Reference: #N128950

22 May 2018

RE: BREWERY YARD, CENTRAL PARK – RESPONSE TO COS'S COMMENTS

**SWEPT PATH ANALYSIS
OF AN 8.8m RIGID
VEHICLE APPROACHING FROM
SOUTH**

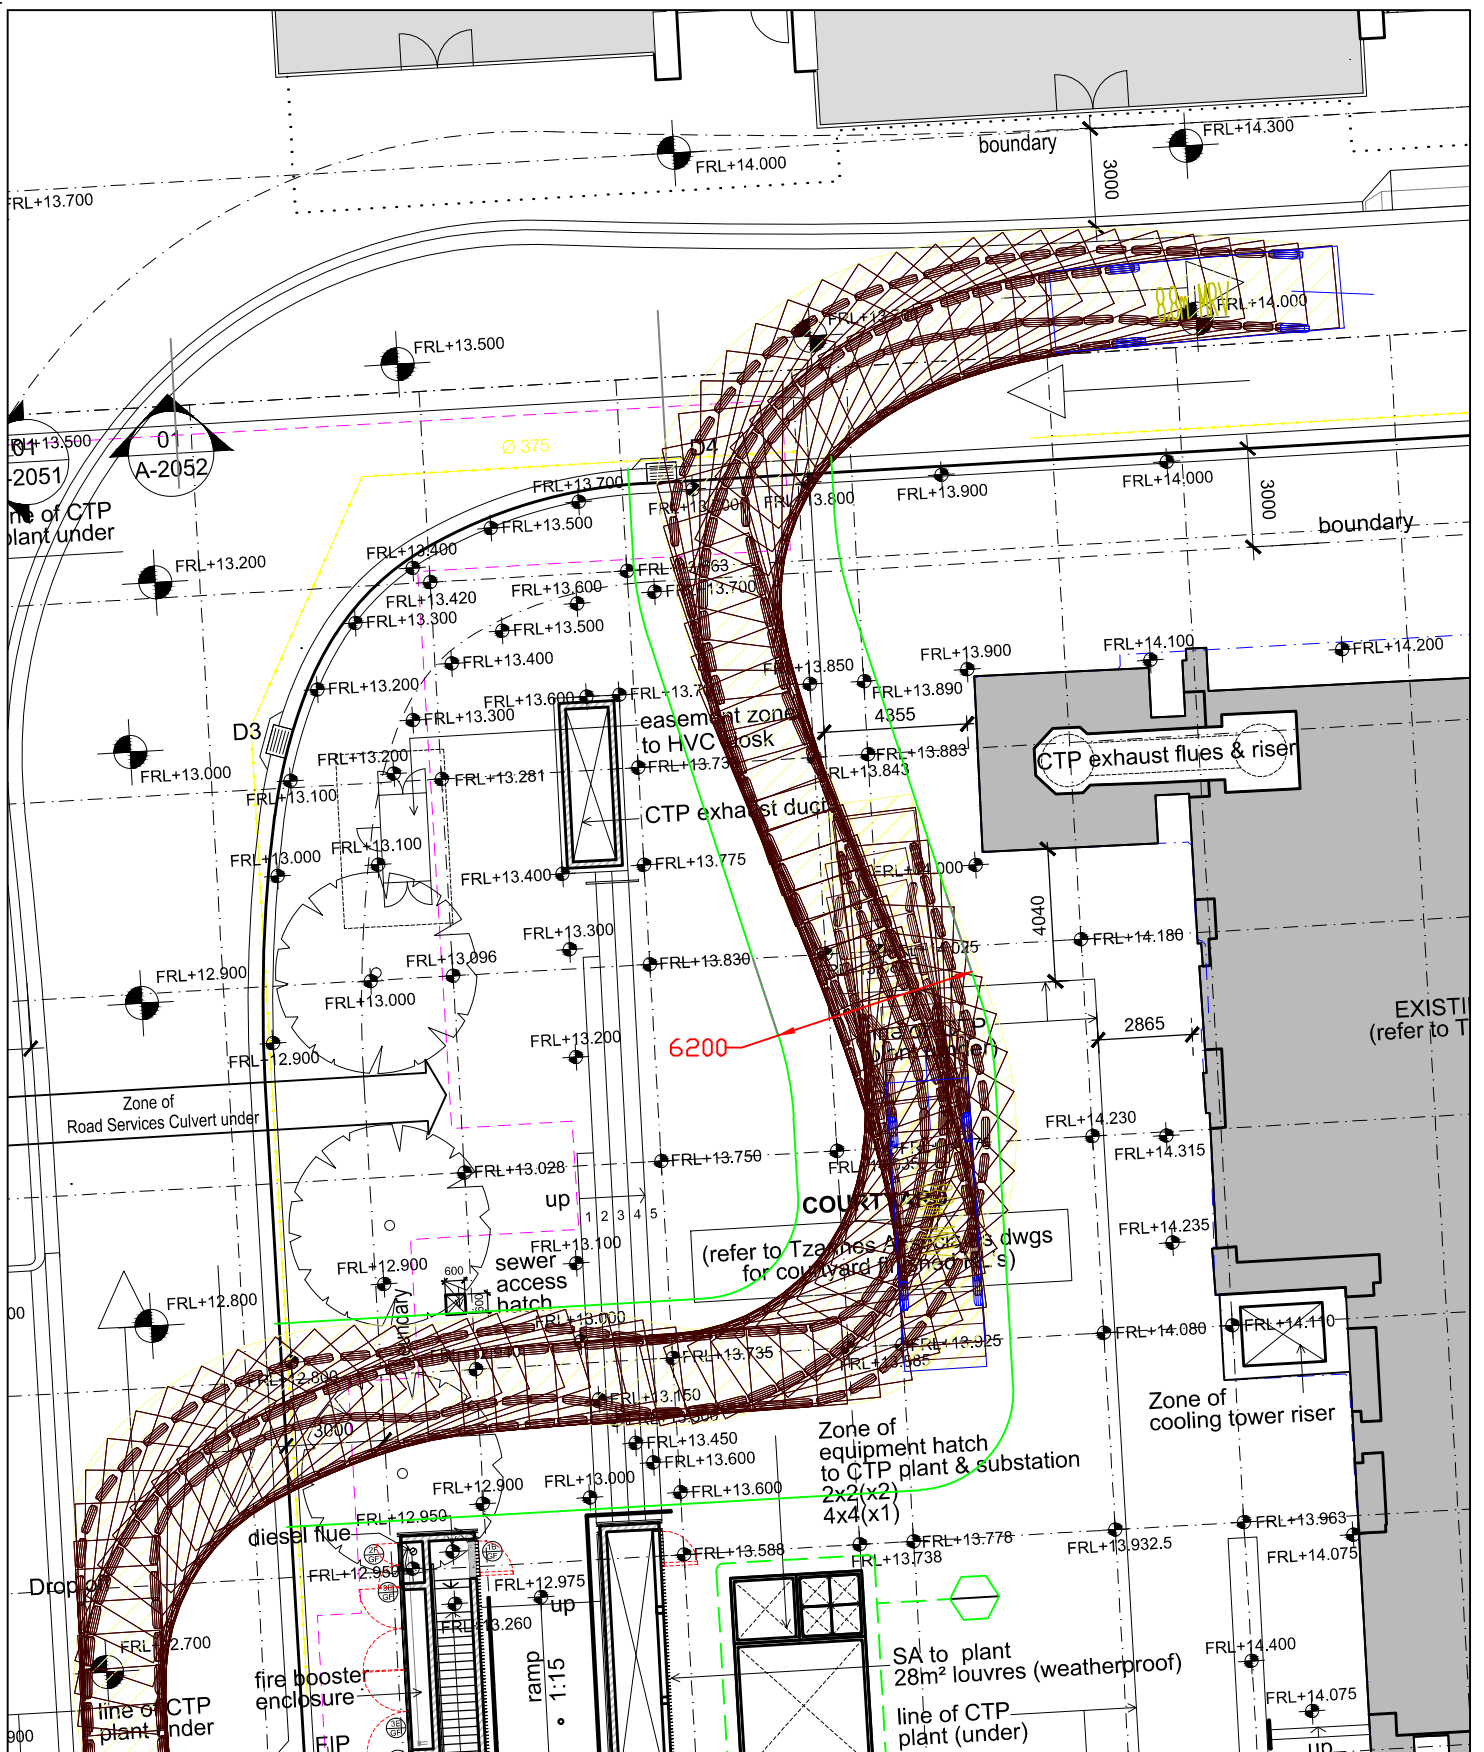
The applicant claims that the proposal does not impact on the pedestrian permeability of the site. This is disputed. The introduction of a private road within what was intended as a pedestrian environment will create an ambiguous space in terms of public accessibility and safety.

It is noted that the proposed private road is in close proximity to an adjacent driveway, an area identified as a future outdoor dining area associated with retail uses and a publicly accessible pedestrian thoroughway linking Block 4b to the public park. The applicant has failed to demonstrate that the proposal will not compromise safety for pedestrians and road users.

Removable bollards at the entry and exit of the proposed private road could be installed outside the proposed access periods to discourage vehicles from entering the site. This would result in increased pedestrian safety on the site outside the proposed vehicle access periods. When the bollards are in place, pick-up and drop-off for the site would occur within the on-street parking areas on Central Park Avenue. The initial MOD 13 swept path assessment with an 8.8-metre Medium Rigid Vehicle (MRV) is shown in Attachment 1, and the swept path assessment for a 6.4-metre SRV restriction is shown in Attachment 2.
